Re: FCC ID LKTEAP-10AMP

Applicant: BreezeCom, Ltd.

Correspondence Reference Number: 7618

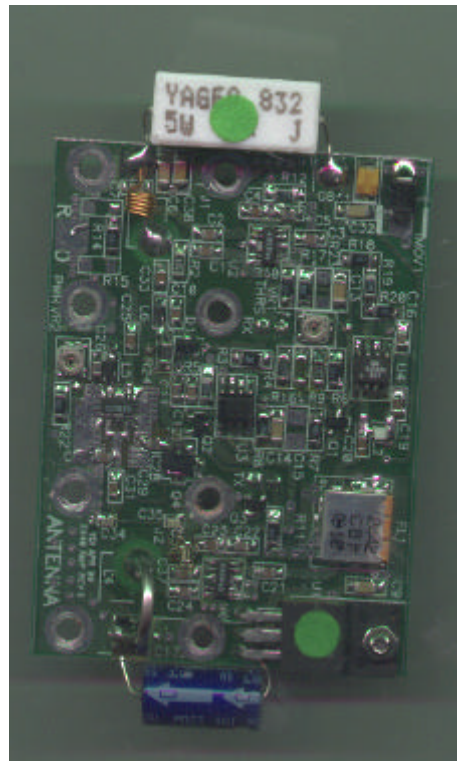
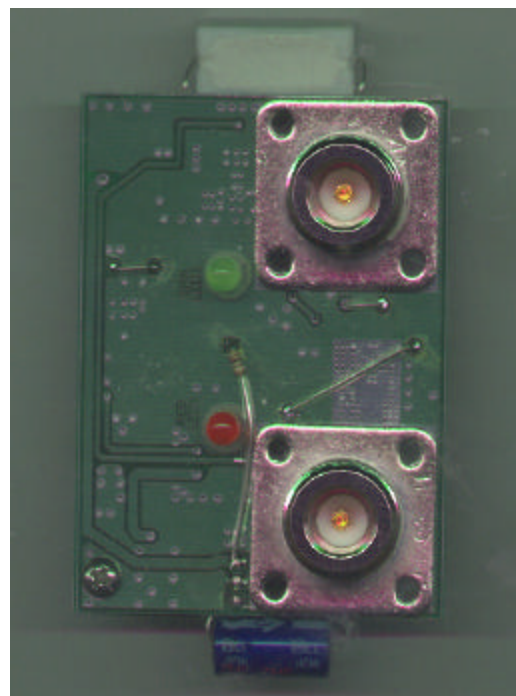
The manufacturer relaid the amplifier PCB so that the external filter would not be necessary. The amp/transceiver and antenna combinations were rechecked for compliance with the commissions rules. The results are very similar in most cases. A few of the harmonic levels improved. The schematics remain the same. I have include new photos of both the component and solder sides of the amp. A new layout incorporates a low pass filter using true inductance and dielectric capacitance in the board to provide the filtering. No other components were added. For any further information, please contact me.
